Work Order ID 109320

Item ID: D212-664-201

Item Name: Aft Crosstube - High

DRAWING NO. D212-664-241	TITLE CROSSTUBE ASSY (205/212 HI AFT)	REV. D	DART AEROSPACE LTD ENGINEERING ORDER		D.E.O. NO. D212-664-241-D-1	SHEET NO. SHEET 1 OF 2	SCALE NTS
DRAWN	CHECKED	MFG. APPR.	APPROVED	DE APPR.			
DATE	DATE	DATE	DATE	DATE

FIGURE 1: SUPPORT INSTALLATION

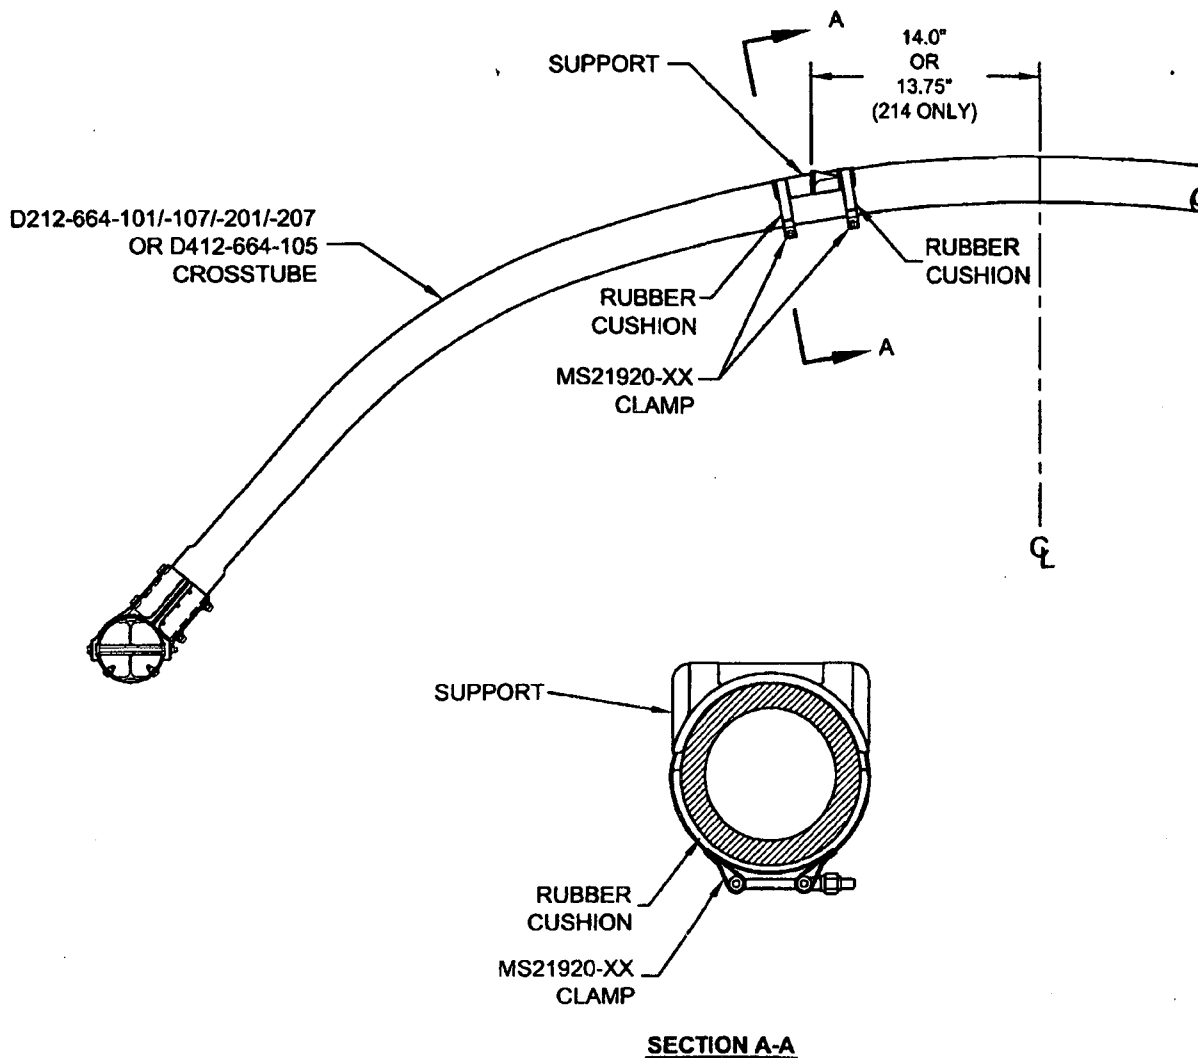
For the crosstubes listed above, section 32.4 of ICA-D212-664 is amended as follows. Use Figure 1 of this service instruction and Figures 32-2 to 32-9 of ICA-D212-664 for further reference. For crosstubes of an earlier change number, it is recommended that if the supports are removed, the supports should be reinstalled using the procedure listed below.

- 32.4.1 Locate the area on the crosstube for installation of support (see Figure 1 of this service instruction). For D212-664-101/-107/-201/-207 and D412-664-105 crosstubes, the outward face of the support tabs should be 14.0" (355mm) from the crosstube center for 204/205/210/412/UH-1 aircraft. For installation on 214B/B-1 aircraft, the outward face of the support tabs should be 13.75" (349mm). Ensure paint finish of crosstube is intact; touch up as required per Chapter 5 (5.3.9) of ICA-D212-664.

- 32.4.2 If present, remove any paint/primer on bottom of supports. Abrade mating surfaces of support and crosstube with 400-grit sandpaper. Saturate a clean cloth with MEK or 4105S Wash'n'Wipe Degreaser or equivalent and wipe until there is no residue.

- 32.4.5 Apply a 0.04" to 0.07" thick layer of Proseal 890 Class B or AMS-S-8802 Class B sealant underneath applicable support and install support as shown in Figure 1 of this service instruction.

- 32.4.6 Install the clamps opposite to crosstube support as shown in section A-A of Figure 1. Install rubber cushions underneath each clamp around the bottom circumference of the crosstube up to the crosstube centerline. Torque clamps 80-100 in-lb (9.0-11.3 Nm). It is acceptable to use smaller or larger sized MS21920-XX clamps than those listed in ICA-D212-664, ensure that after torquing the clamps per this instruction, the nuts are in safety but not bottomed out

D212-664-241/-241B
ASSEMBLY DETAIL

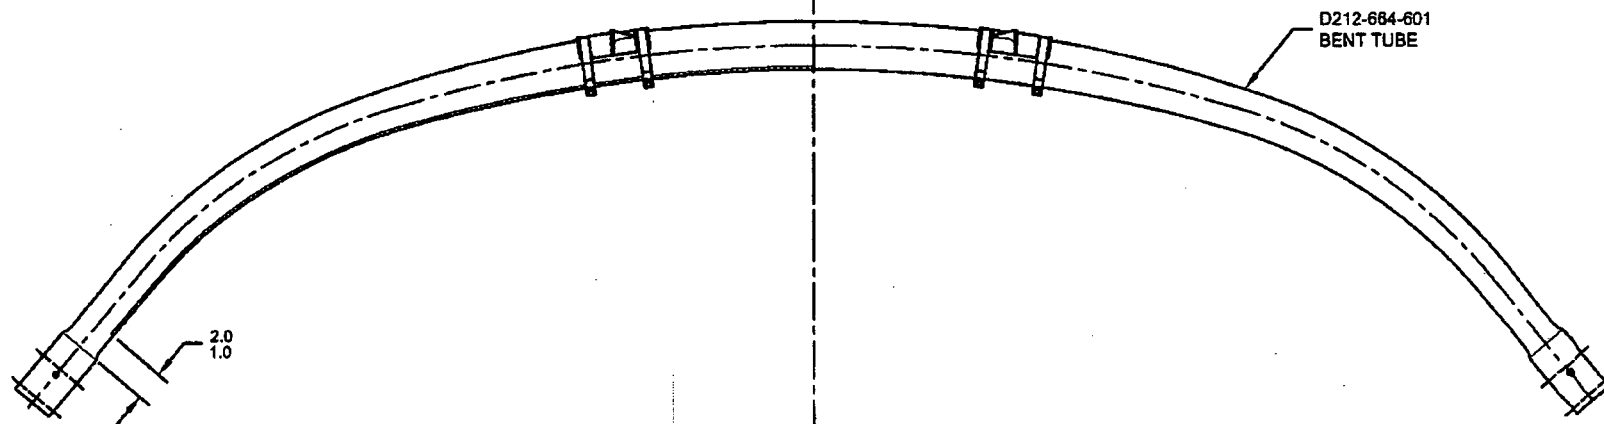
ADD AN INSPECTION WINDOW TO UNDERSIDE OF CROSSTUBE.

NOTES 2 OF SHEET 1 IS AMENDED AS FOLLOWS:

- 2) FINISH: CHEMICAL CONVERSION COAT PER DART QSI 005 4.1
PRIME INSIDE AND OUTSIDE PER DART QSI 005 4.2
MASK UNDERSIDE OF CROSSTUBE AS SHOWN (HATCHED AREA) AND
PAINT OUTSIDE PER DART QSI 005 4.2
REMOVE MASKING AND APPLY CLEAR COAT

MASK AREA PRIOR TO PAINTING,
REMOVE MASKING AFTER PAINT
AND APPLY CLEAR COAT

NOTE 12 & 15, SHEET 1 IS AMENDED AS FOLLOWS:

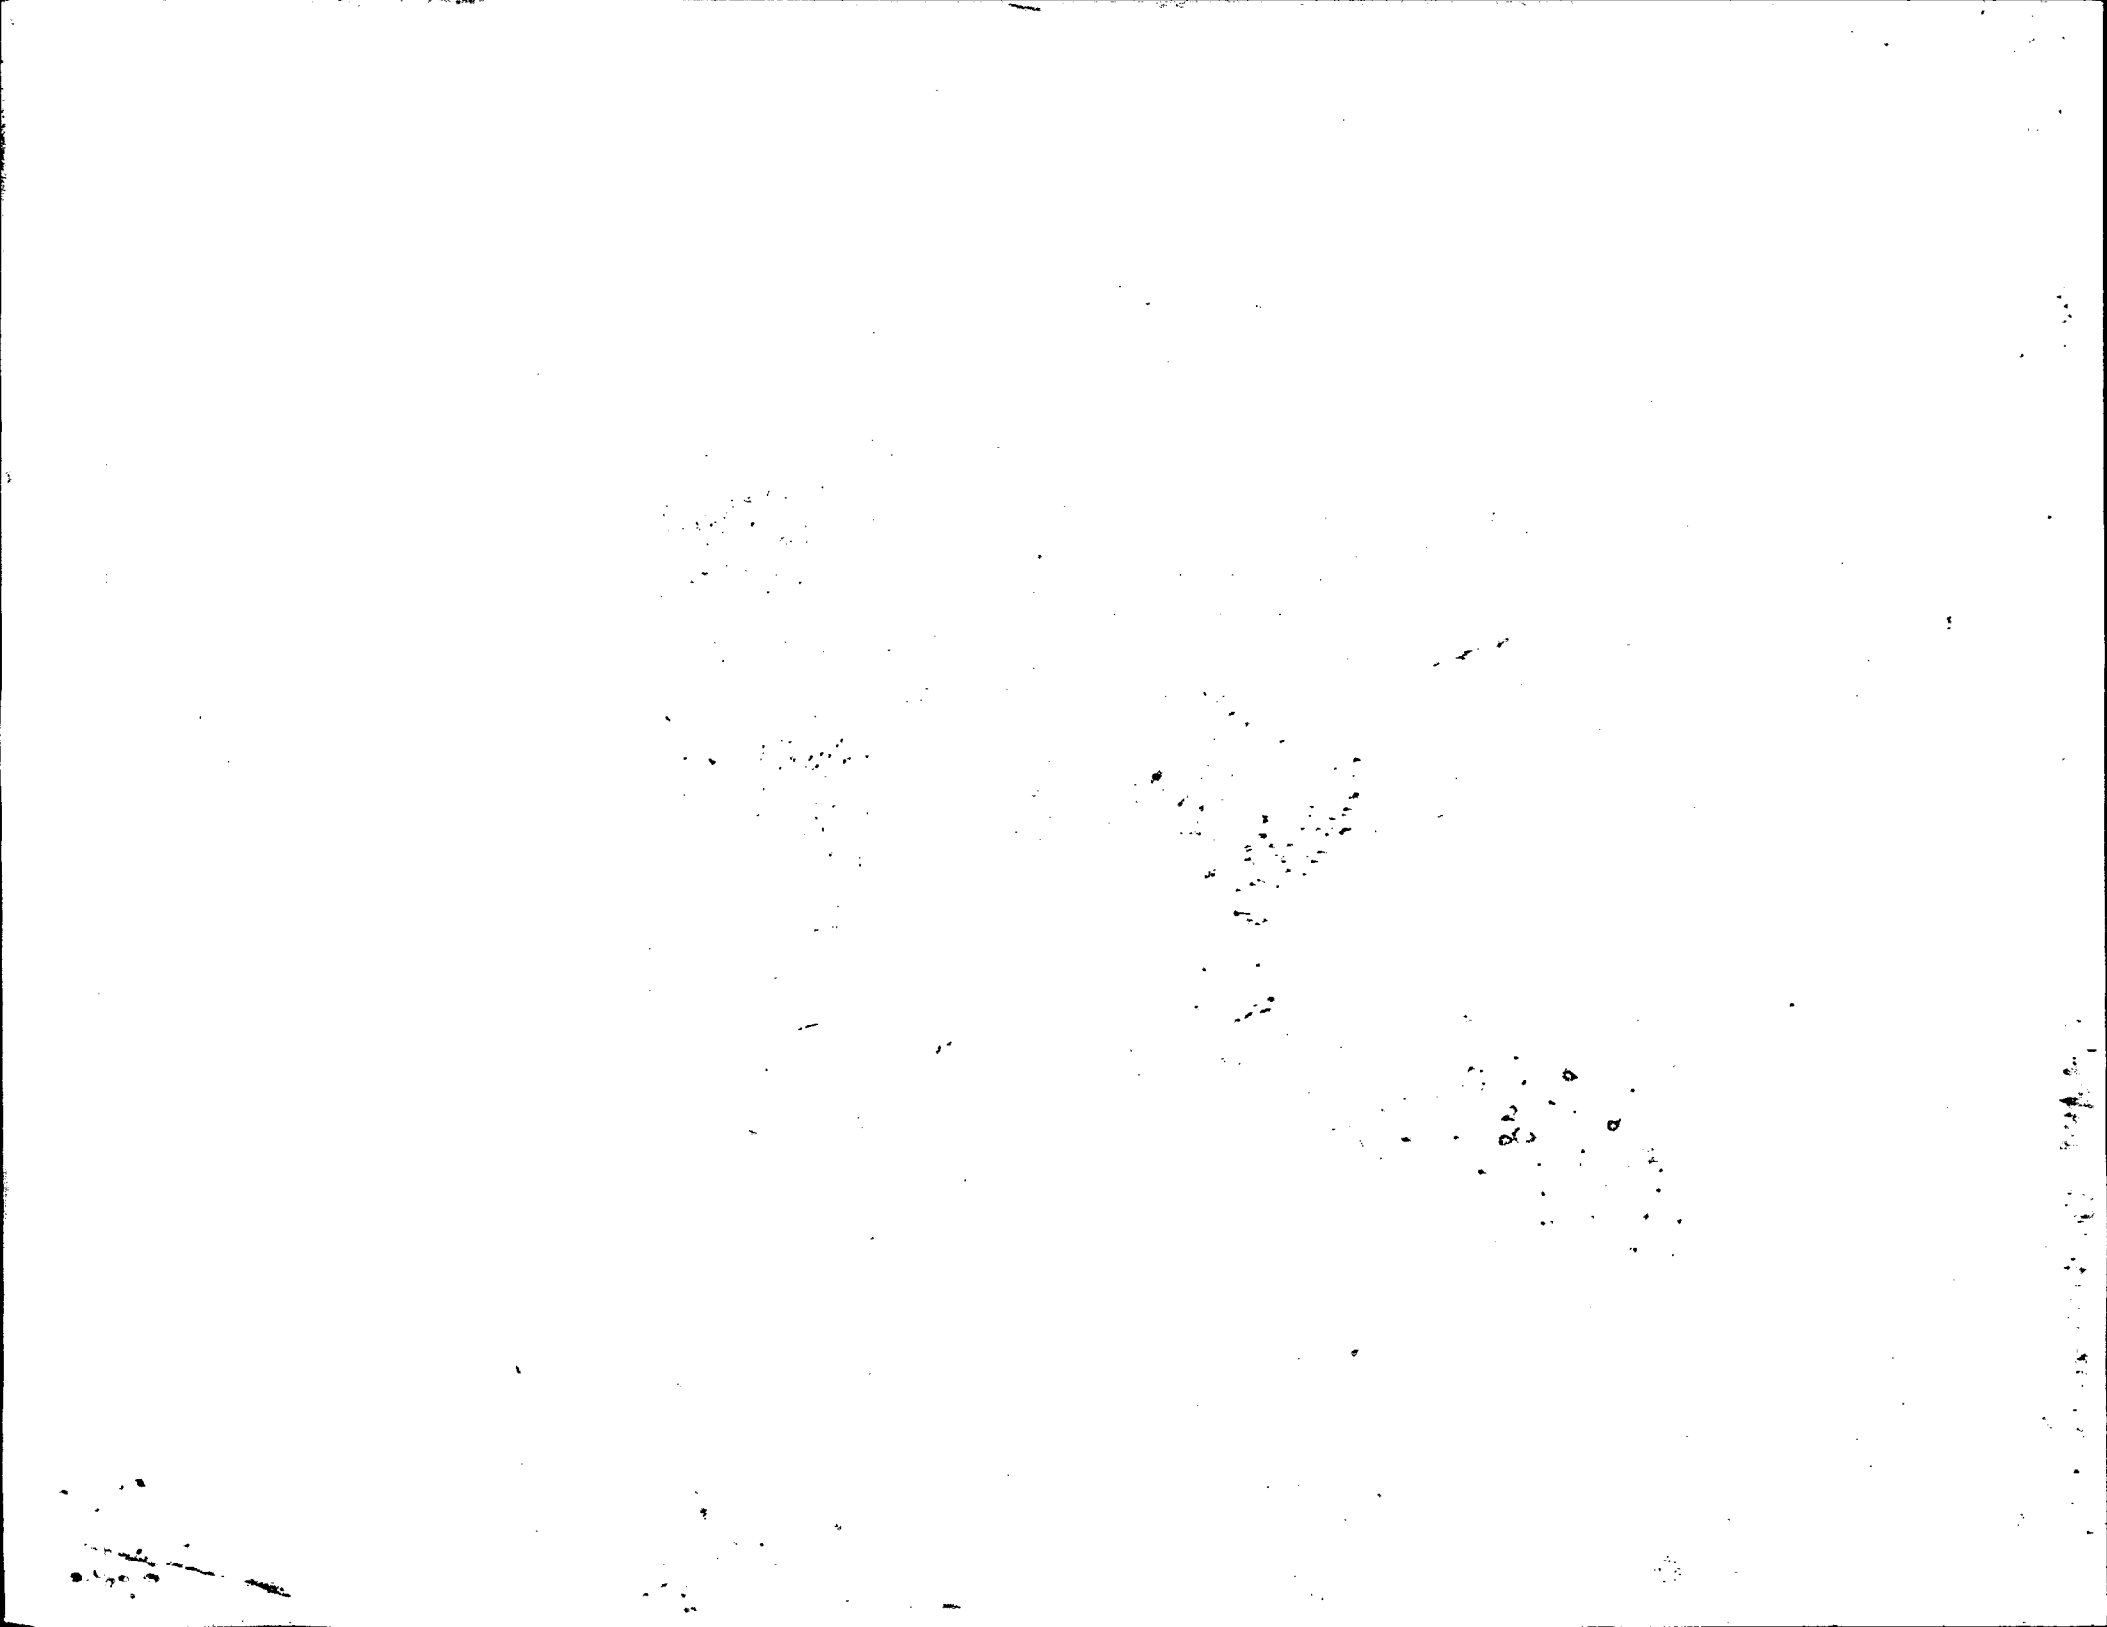
REPLACE MAGNOBOND WITH PROSEAL.

7	A/R	A/R	MAGNOBOND 6398	ROCKWELL SPECIFICATION RBO-120-023 ADHESIVE (TEXTRON/BELL SPEC. 299-947-100, TYPE II, CLASS 2 ADHESIVE)
---	-----	-----	----------------	---

- 12) TO INSTALL D2940-1 SUPPORT: ABRASE MATING SURFACE OF SUPPORT AND CROSSTUBE WITH 180-GRIT SANDPAPER AND REMOVE RESIDUE WITH MEK (OR EQUIVALENT). APPLY A 0.04" TO 0.07" THICK LAYER OF PROSEAL 890 CLASS B-2 (OR AMS-S-8802 CLASS B-2) SEALANT TO MATING SURFACE OF SUPPORT.
- 15) TORQUE CLAMPS 80 TO 100 IN-LB. ENSURE AT LEAST 1.5 THREADS SHOWING IN SAFETY AND THAT NUT HAS NOT BOTTOMED-OUT AFTER TORQUING. **PRIOR TO PACKAGING, RE-CHECK TORQUE ON CLAMPS AFTER PROSEAL 890 SEALANT HAS CURED FOR 72 HOURS.**

Acceptability of 8% CRUSHING

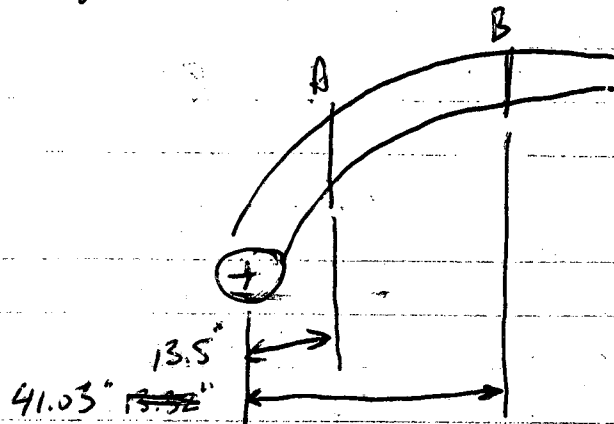
CRUSHING OF D212-664-201

Point A: $OD1 = 2.548 \text{ in}$ $OD2 = 2.992 \text{ in}$
 $CRUSHING = (2.992 - 2.548) / (2.992 + 2.548) = 8\%$
 $I = 1.476 \text{ in}^4$
